SUBJECT: ISSUANCE OF AMENDMENT NO. 77 TO FACILITY OPERATING LICENSE
NO. NPF-21 - WPPSS NUCLEAR PROJECT NO. 2 (TAC NO. 66885)

Amendment No. 77
License No. NPF-21

ENCLOSURE TO LICENSE AMENDMENT NO. 77

**Reduced Flow MCPR Operating Limit
Figure 3.2.3-1**

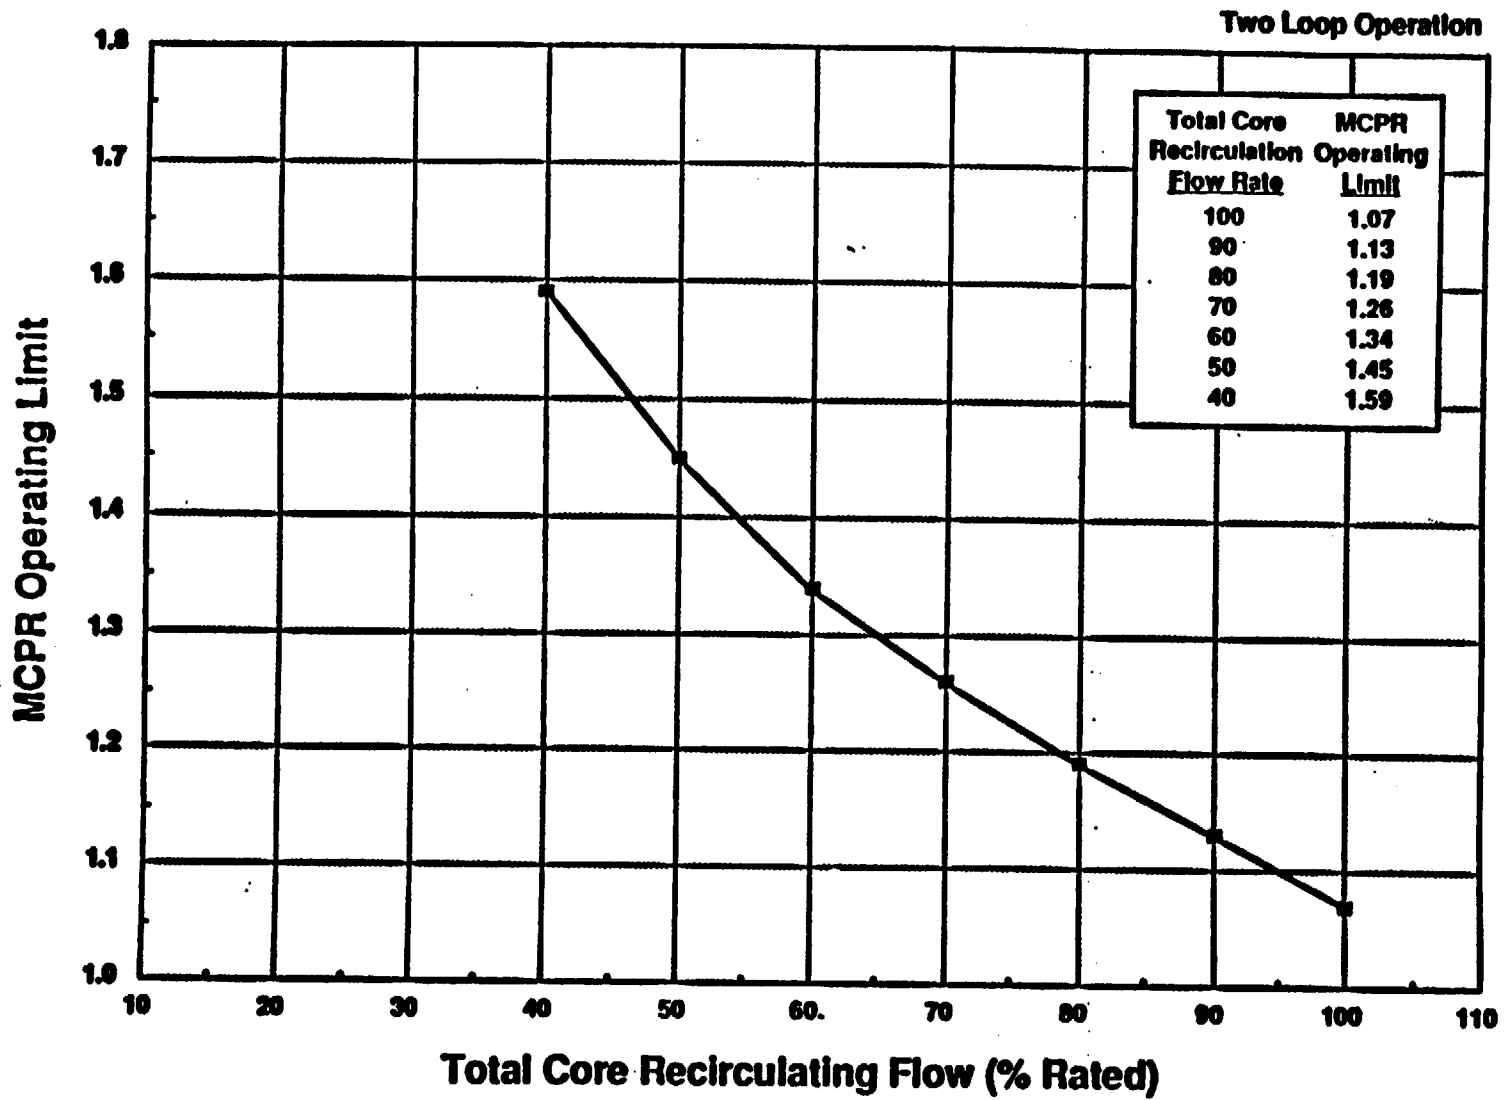
Note: This curve is also applicable to FFTR operation

3.4 Figure 3.2.3-1

The note below the figure is revised to remove the phrase "when approved" since the issuance of this amendment constitutes approval of final feedwater temperature reduction. The curve is supported by analytical results and is acceptable.
